ADDENDUM

December 15, 2017

RFB NO. 317028 - ADDENDUM NO. 1

SCHUMACHER BARN REMODEL/SITE IMPROVEMENTS (REBID)

**PLUMBING RISERS,
SCHEDULES
& DETAILS**

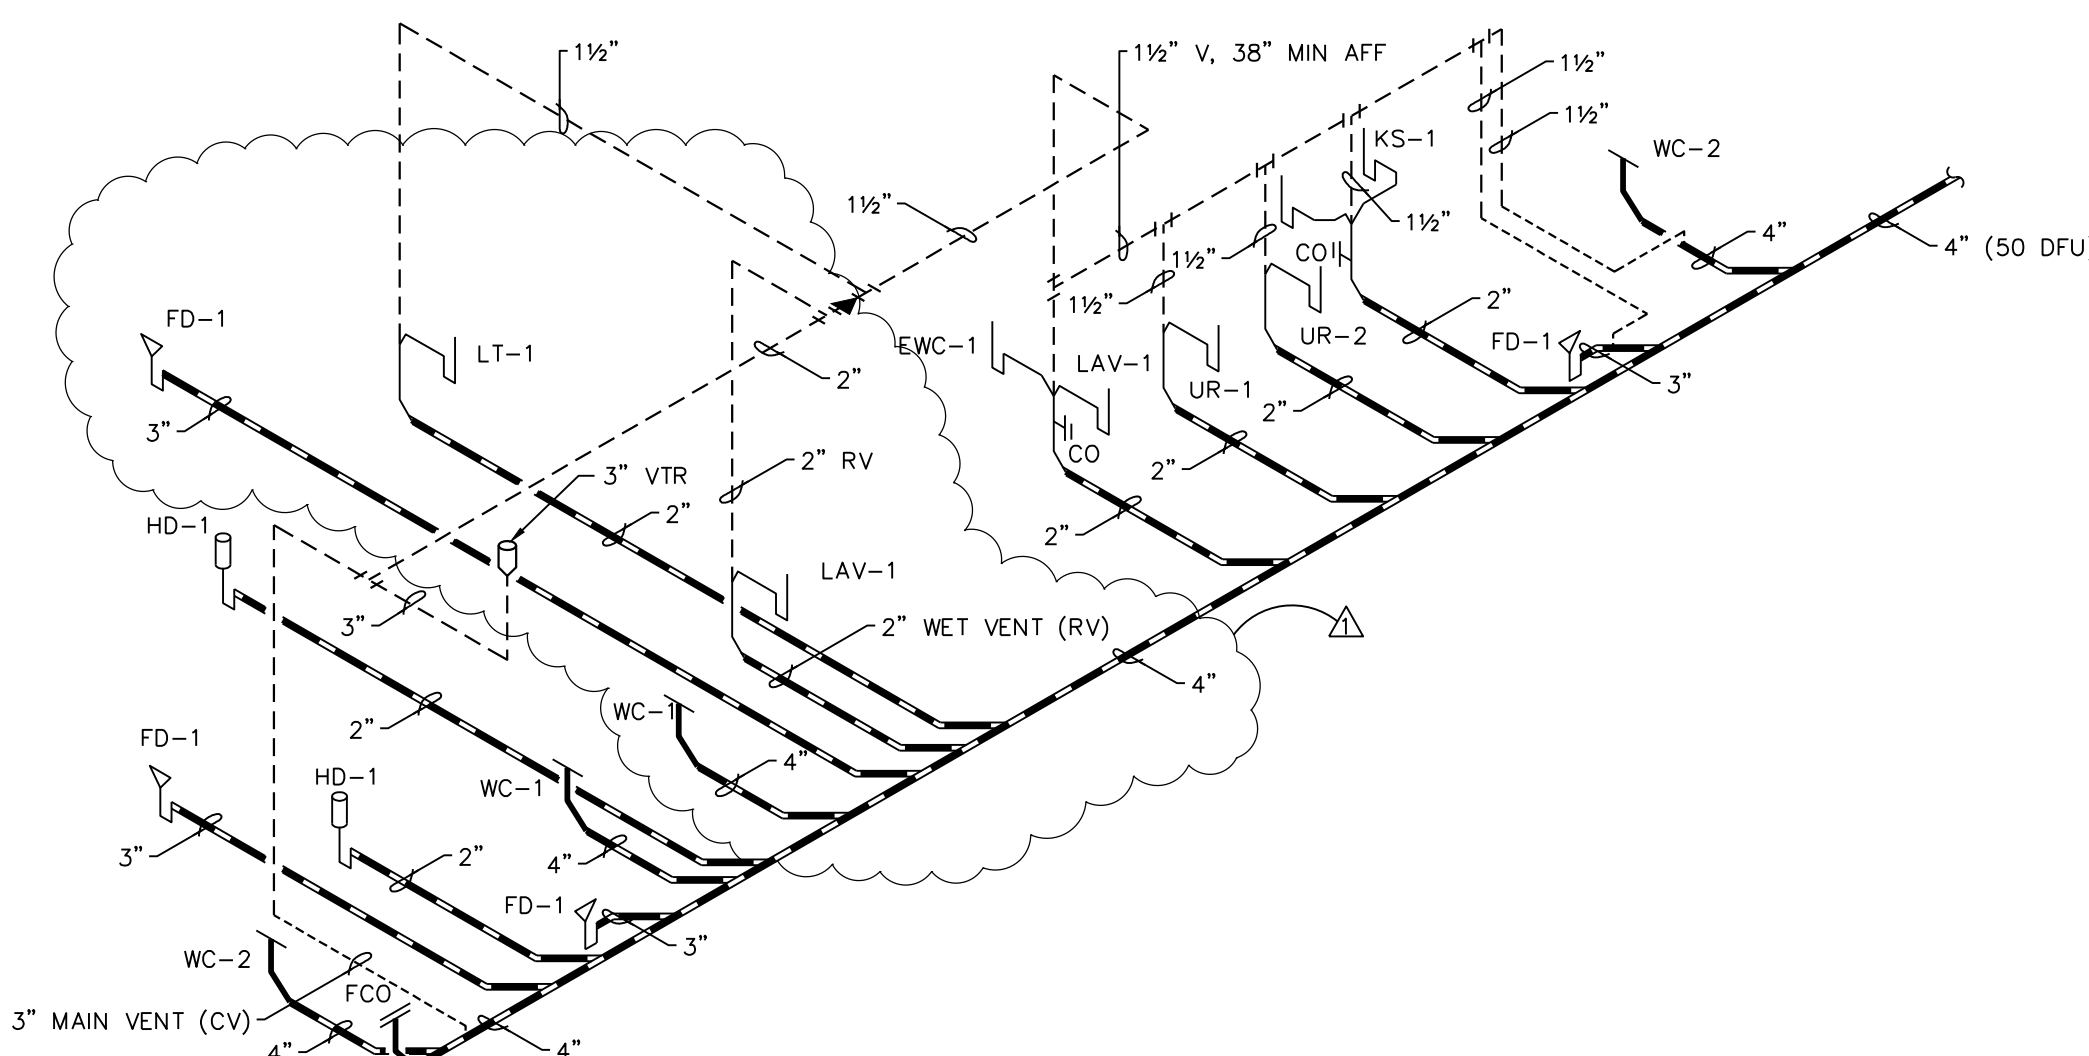
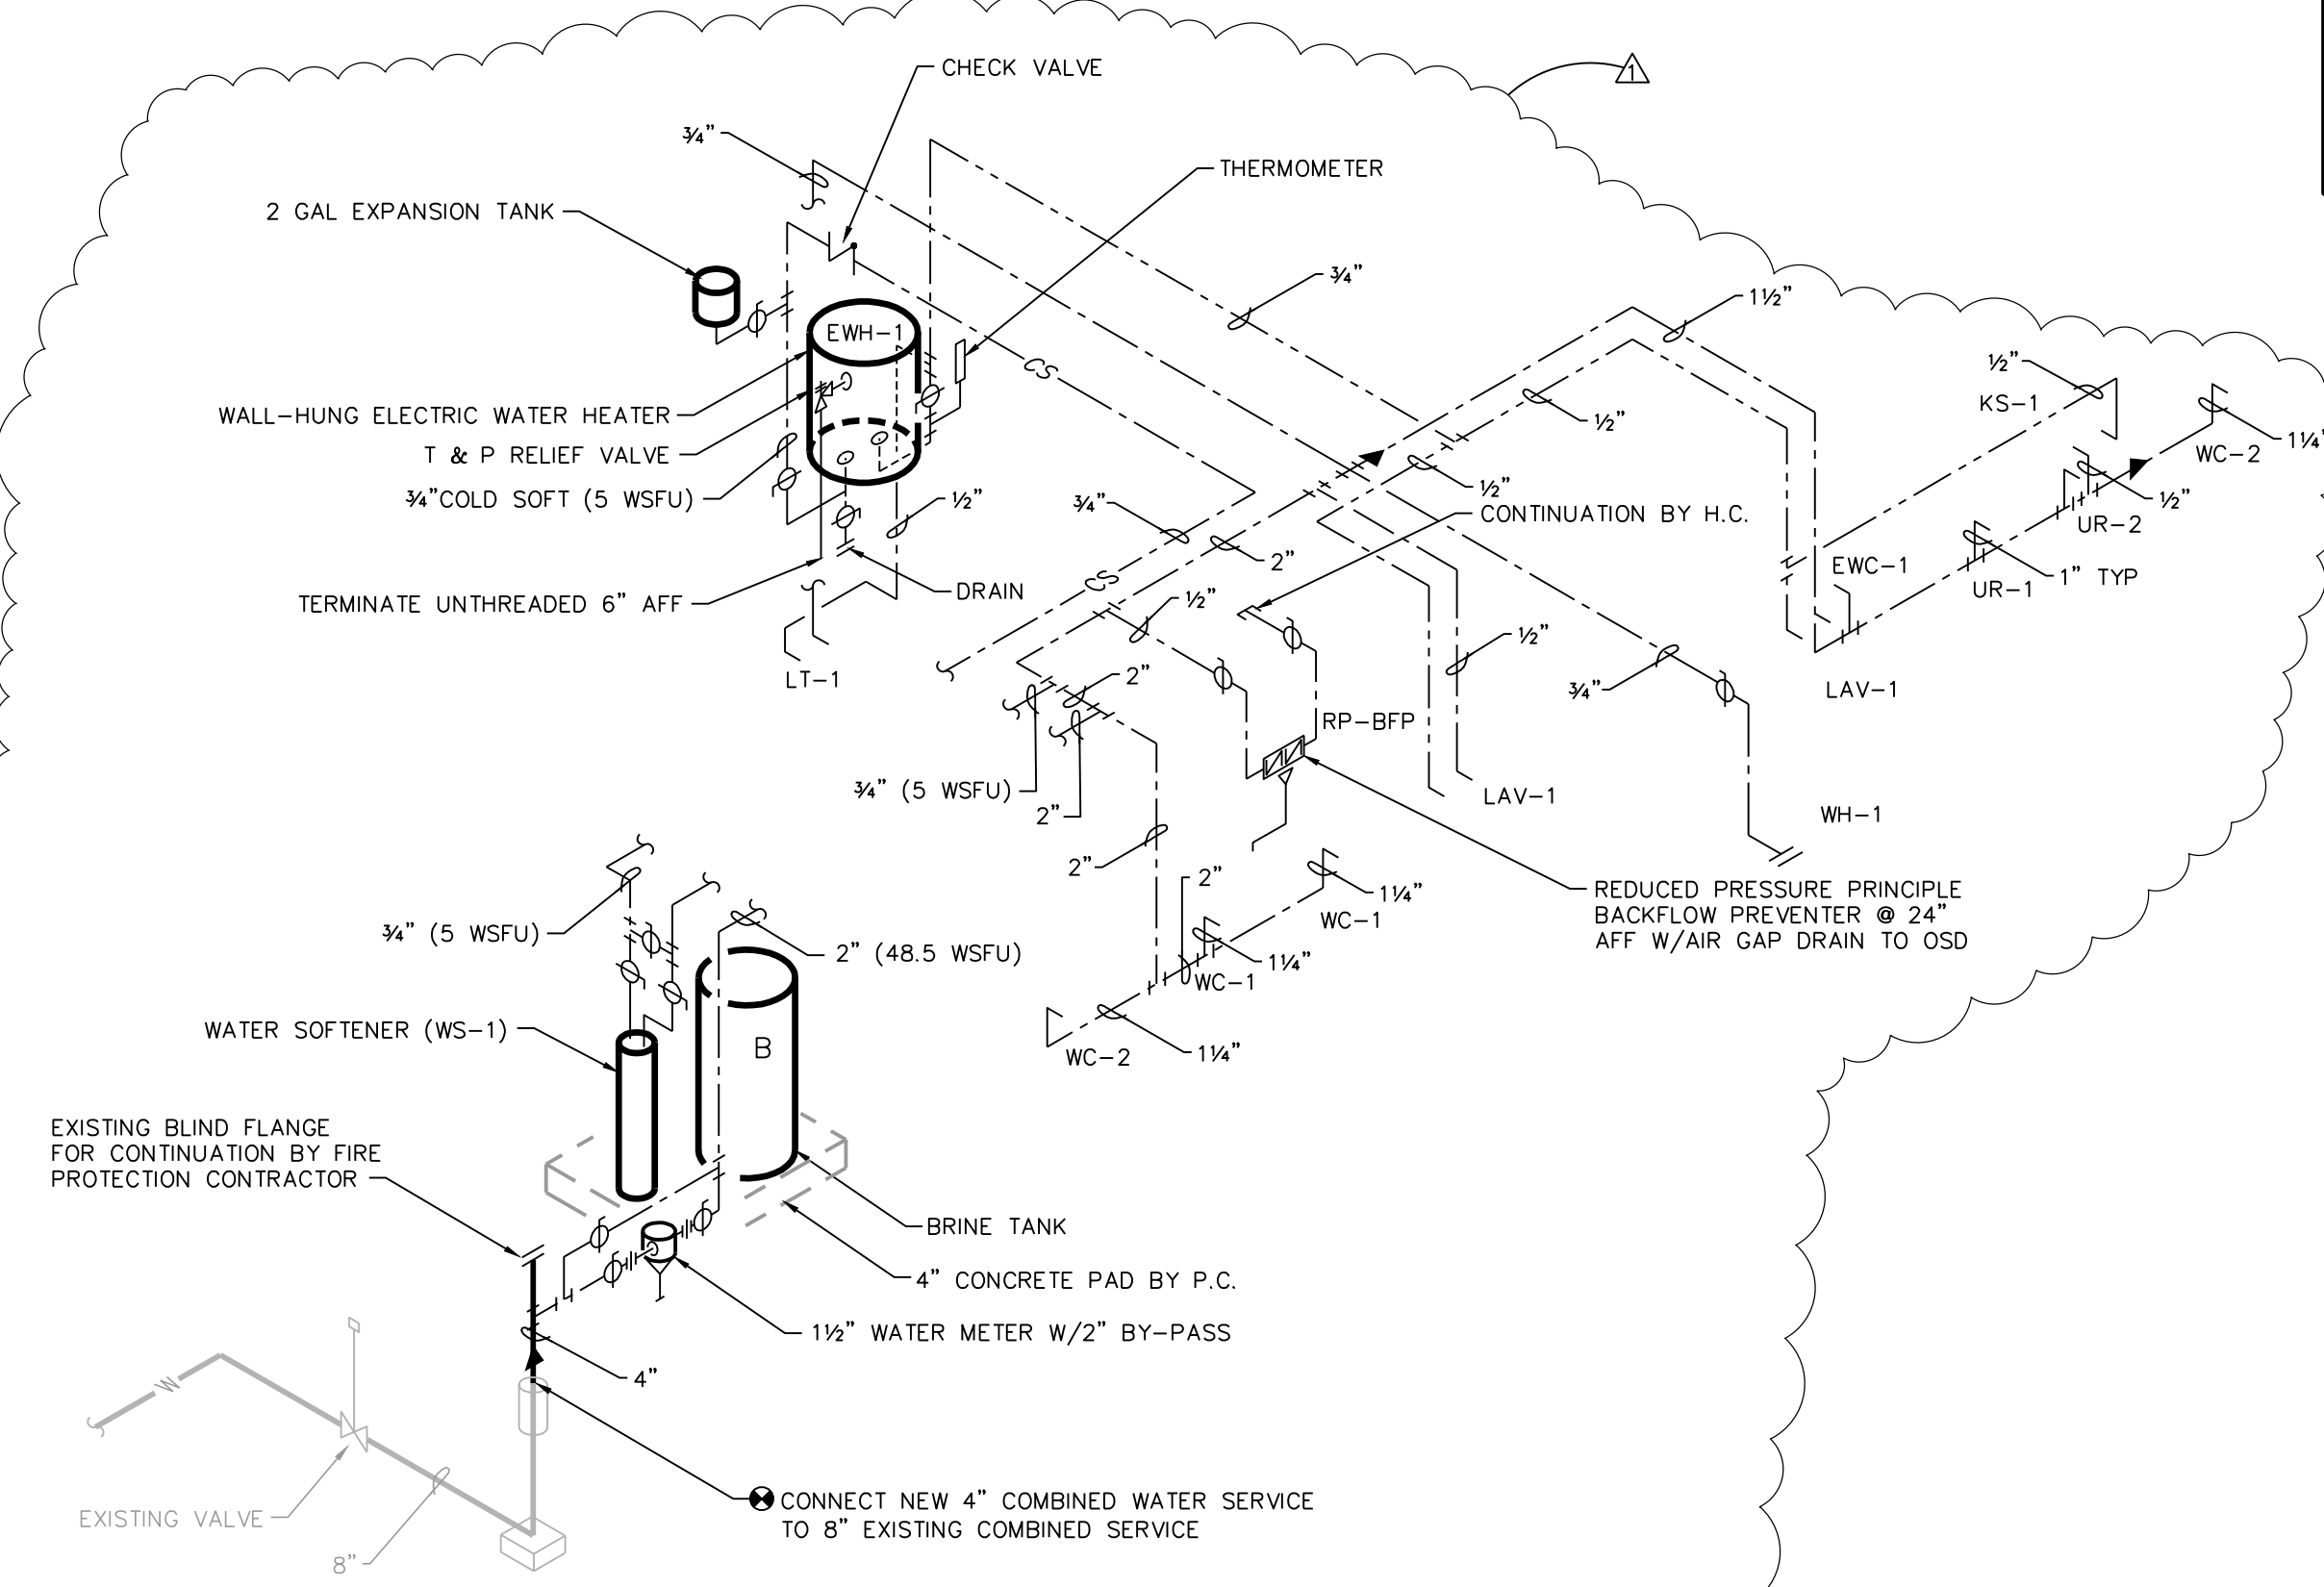
28. Sheet P2.0 - PLUMBING RISERS, SCHEDULES & DETAILS

Delete current Sheet P2.0 and replace with new Sheet P2.0, issued with this Addendum.
Modified water pressure service to 32 psig and related water sizing calculations.
Modified waste and water risers.
